RENAISSANCE
CÉNTRO

**Re: Zoning Determination Letter
 2109 M Street NW – Square 70, Lot 880 (part of record lot 190)**

Thank you for meeting with us to review the current development plans for 2121 M Street NW and confirm (or in some cases, reconfirm) the application of the Zoning Regulations. The property is located in Square 70, Lot 880 (part of record lot 190) ("Property") in the CR Zone District. We propose to construct a hotel with 168 rooms, some ground floor retail and function room spaces, and 34 parking spaces, as shown on the attached plans ("Project").

From: Avitabile, David
Sent: Sunday, November 10, 2013 12:32 PM
To: 'Ndaw, Mamadou (DCRA)'
Cc: 'LeGrant, Matt (DCRA)'; Epting, John; 'Ilan Scharfstein'
Subject: 2121 M Street (B1310607) - Response to Zoning Review Comments
Attachments: RE: 2121 M Street -- Review of our discussion; 2121 M Street -- Review of our discussion; Determination Ltr re 2109 M St to Epting 12-6-2010.pdf; At-Grade Connections.pdf; Valet Parking Plan.pdf; Hyatt Place M Street Rooftop Structures .pdf; Hyatt Place M St Site Plan - loading.pdf

Valet Parking Plans

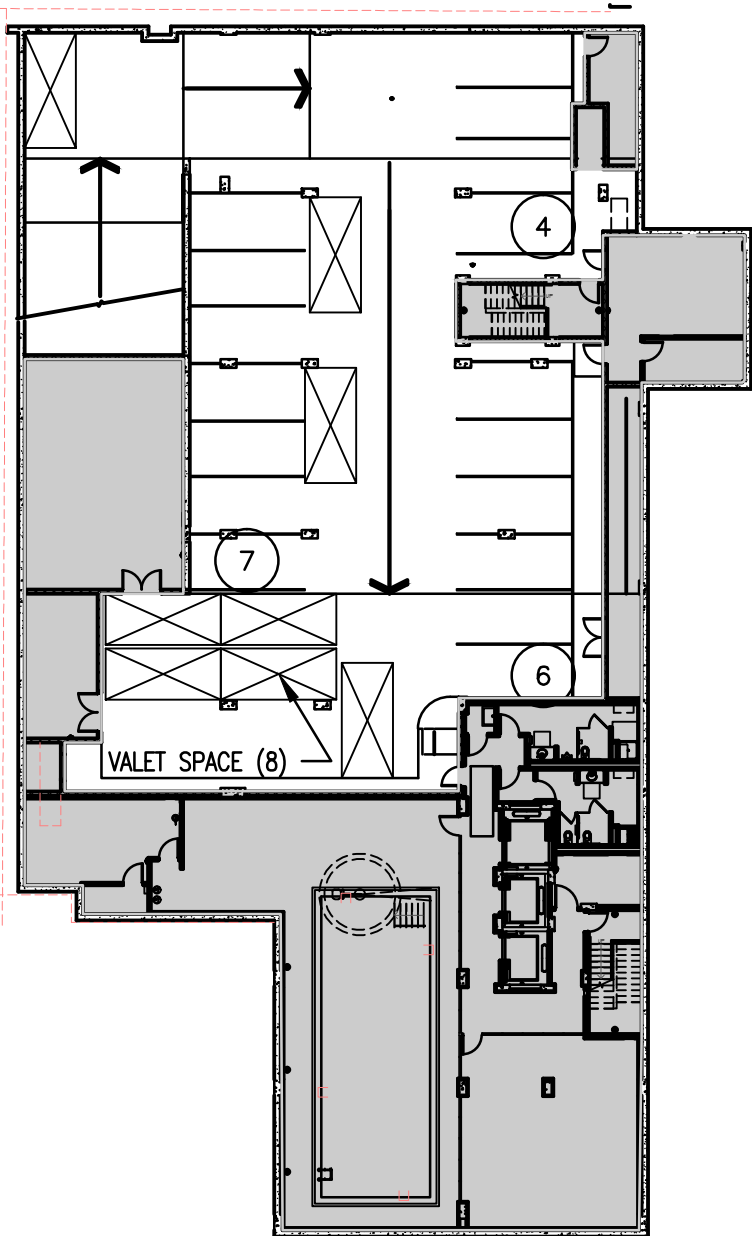
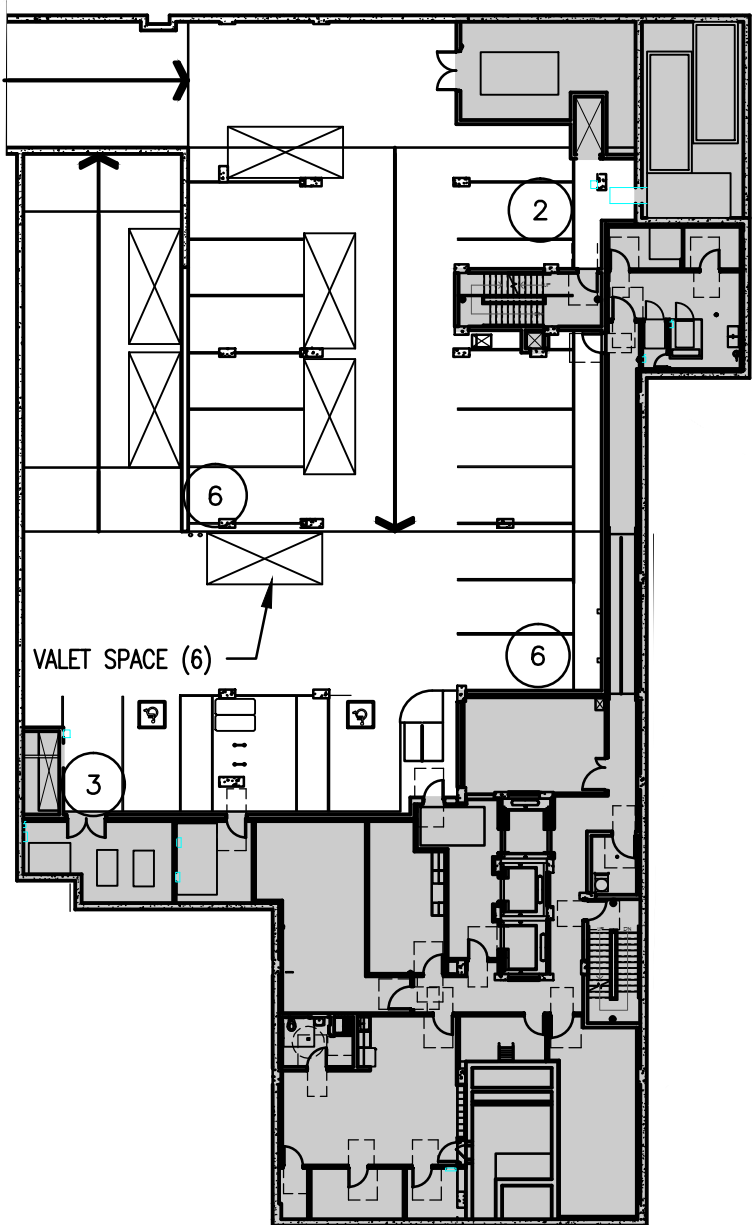
Section 2101.1: The building has 168 rooms and a 1,710 s.f. function room, for a total parking requirement of 48 spaces (1 per 4 rooms and 1 per 300 s.f. of the largest function room space). We are going to exercise our prerogative under Section 2115.9 to use valet parking to meet our parking requirement. With valet operations, we can provide all 48 spaces within our garage. See attached valet parking plan.

Section 2117.4: Good question. As is noted on the Lower level 1 plan of the Valet parking plan, our parking garage is accessed directly from 22nd Street via an unobstructed private drive that runs under the existing Washington Marriott to our garage. The ramp exists now; we just need to connect to it. We have provided a plan that shows the required loading spaces; the architects have also shown the location of the ramp.

Loading Plan

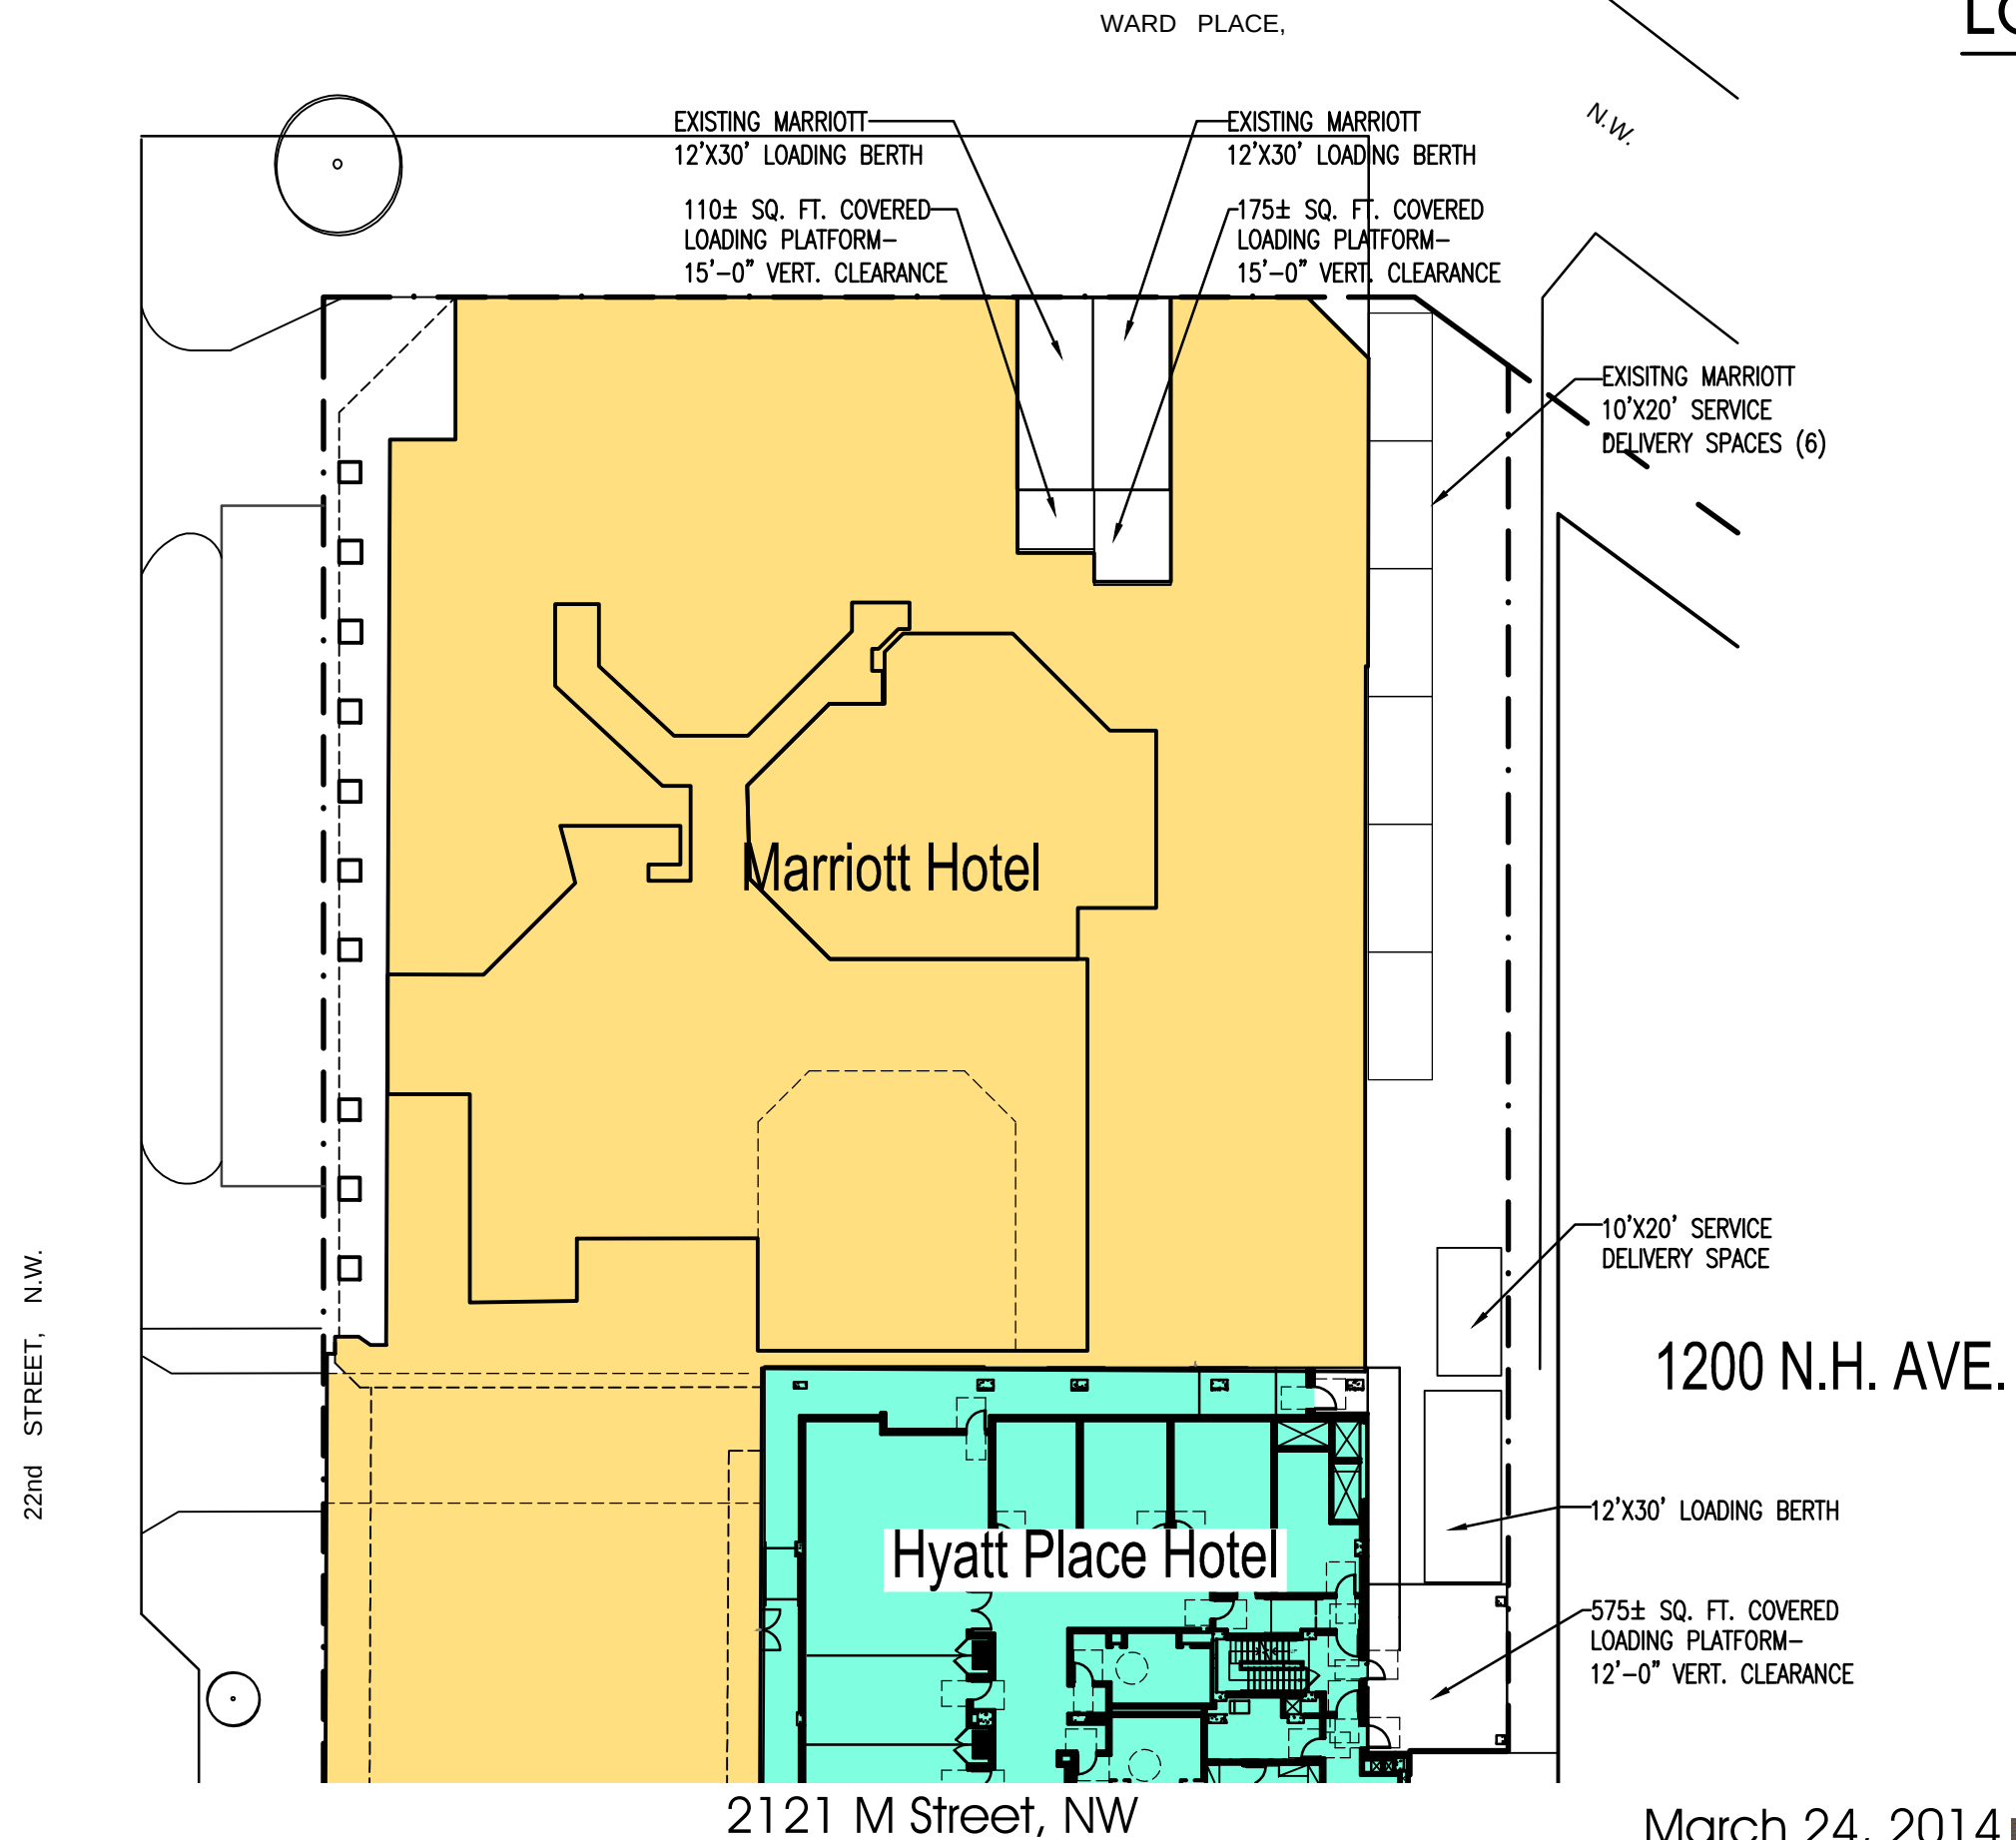
7. Please clearly identify and dimension on the site or floor plans, the loading berth, loading platform and service/delivery spaces. Please comply with minimum vertical clearance for loading berths per §2201.6 and §2204.2 access to loading berth, platform, etc.

- As we discussed, the Project triggers a loading requirement for one 30-foot deep berth, one 100 square foot platform and one 20-foot deep delivery space. This loading may be located anywhere on the record lot and will be provided as shown on the proposed plans.

Roof Structure Plan

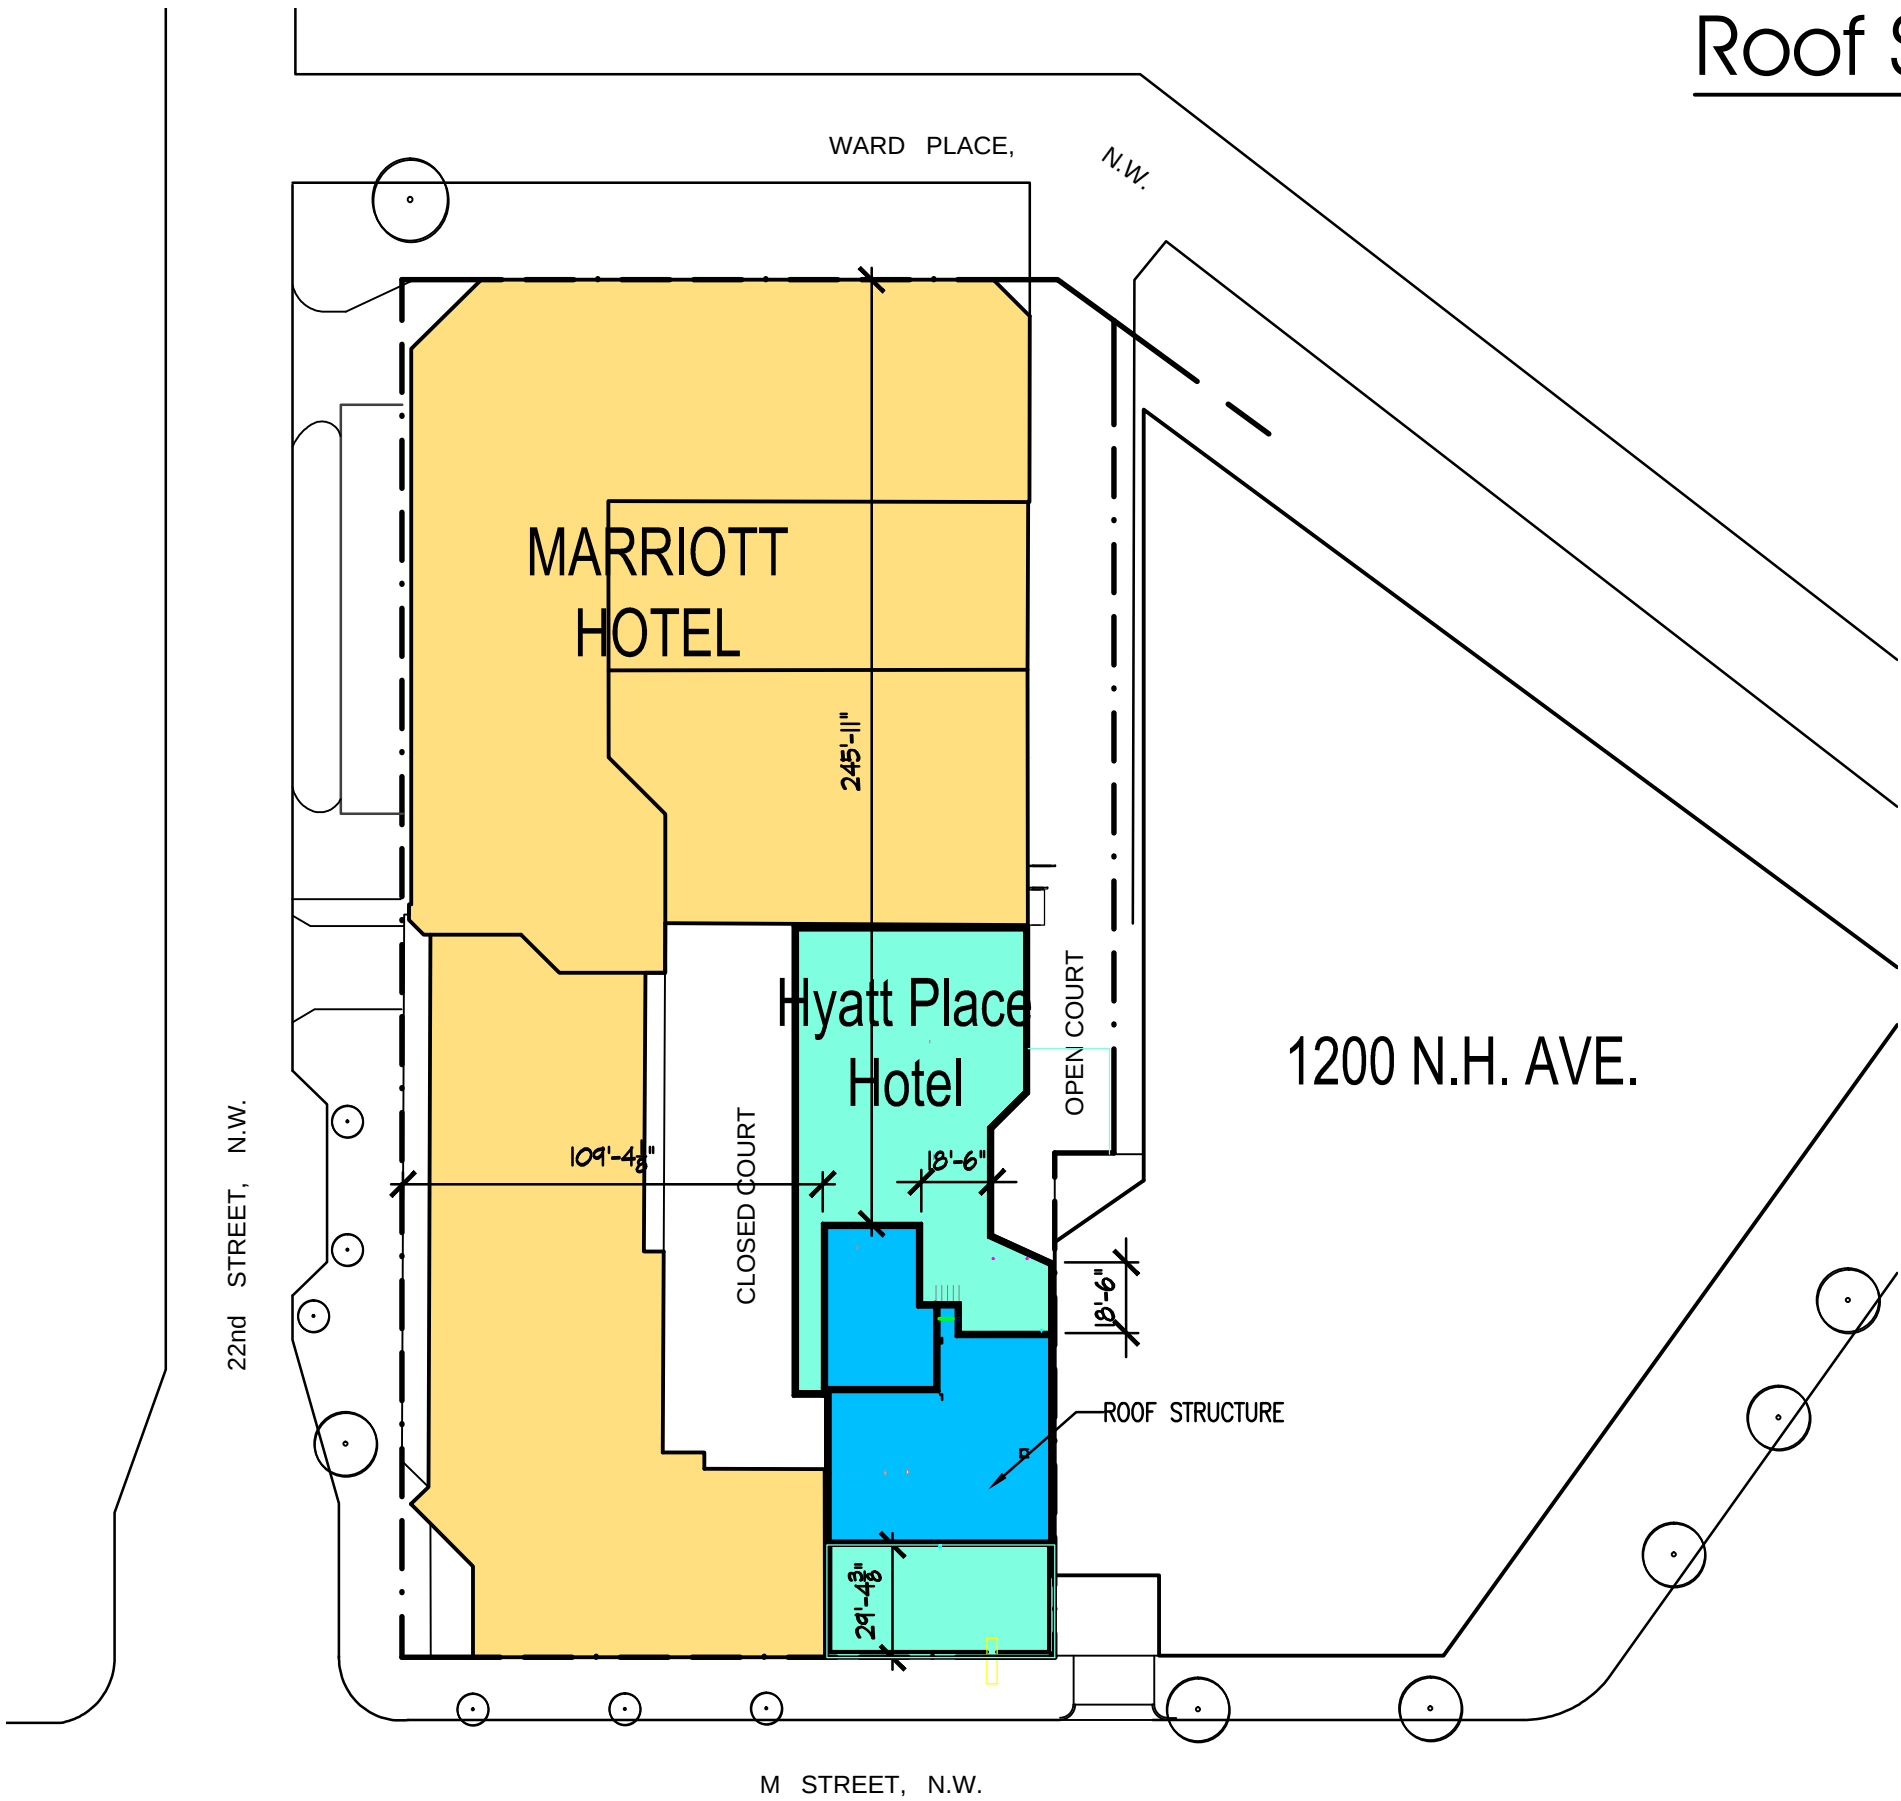
- As we discussed, the proposed Project contains a roof structure that is set back from all exterior walls (that is, the south wall that faces M Street and the north wall that faces the open court). No setback is required from the east wall, which is a lot line wall that abuts another 90-foot tall building, or from the west wall, which faces a closed court within the single record lot.
- Pursuant to our discussion, we have modified the roof structure to reduce the amount of accessory space within the structure and clarify that the enclosed space is intended to be used for uses that are accessory to the rooftop recreation space , as shown on the attached plan. Please confirm that the revised roof plan is acceptable.

Thanks for the clarification, as well as illustrative plans that were attached to your email. By this email I am confirming my agreement with its analysis, and its conclusion that the areas of the rooftop structure comply with Section 411 of the Zoning Regulations.
